Tawheed Center of Novi, JSP15-35

Consideration of the request of TCNN for Preliminary Site Plan approval. The subject property is located in Section 27 at 24101 Novi Road on the south side of Ten Mile Road, west of Novi Road, in the OS-1, Office Service District. The subject property is 2.2 acres and the applicant is proposing to remove an existing canopy over the former drive-up lanes, re-stripe the existing parking lot and seek approval to landbank eight parking spaces.

Planning Review

Engineering Review

Site Plan

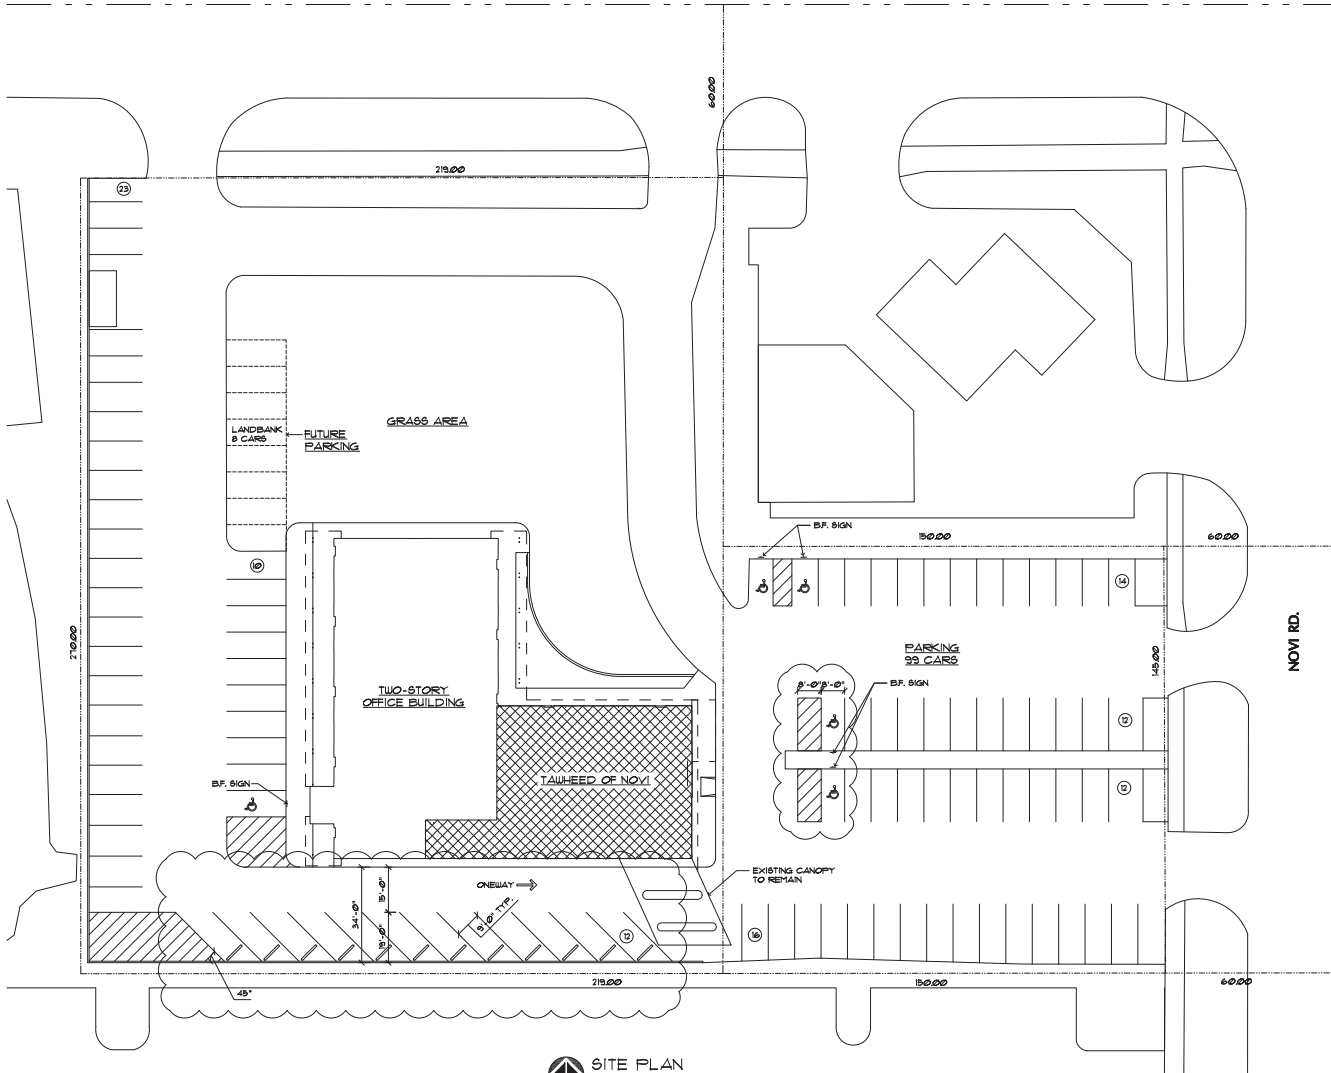
3. Existing Canopy: The applicant has indicated verbally that the existing canopy for the former bank use will be removed. However, the plans show it remaining. **The canopy should be removed to allow adequate circulation on the site.**

- c. The applicant should consider providing the length of the two (2) 90° proposed handicap parking spaces to ensure compliance with City standards.
- d. Section 5.3.12 of the City of Novi's Zoning Ordinance requires a raised end island "at the end of all parking bays that abut traffic circulation aisles". The plan currently does not show constructing any raised end islands. If there are low traffic circulation volumes for this site, **the applicant could request a waiver from the City to install painted islands as opposed to raised end islands.**

- e. The applicant appears to be adding five (5) parking spaces to the existing 90° parking along the south edge of the site which results in a row of 16 parking spaces. Per Section 5.5.3 of the City of Novi's Zoning Ordinance, one landscape island is required for every 15 parking spaces. The applicant should consider either adding an end island, removing one (1) proposed parking space or **requesting a waiver from the City.**

1. The existing rear (west) parking bay exceeds the 15 space maximum by 8 spaces.
2. If the land-banked spaces were built, that bay would exceed the 15 space maximum by 3 spaces.
3. The proposed expansion of the southern bay exceeds the 15 space maximum by 1 space.
4. Adding landscape islands with canopy trees on both ends of the proposed angled parking would focus the interior traffic better, add to the site's attractiveness and partially meet the city's parking lot landscaping requirements.
5. Please add those islands and landscaping.

Area of concern is the back drive –south route (old one-way access for bank teller). This road is listed on prints as 15' wide after new parking lot lines are completed. If this road is to be listed as a "Fire Lane", the minimum road width requirement would be 20'.

TCNA will remove existing canopy for the former bank to allow adequate circulation on the site.

TCNA requesting a waiver to allow barrier free access aisle in lieu of raised end islands.

TCNA will submit the plan showing Landscape Island between existing rear (west) parking and proposed land-banked spaces.

TCNA will submit the plan showing end islands on both ends of proposed angled parking following the standards and ordinance of the City.
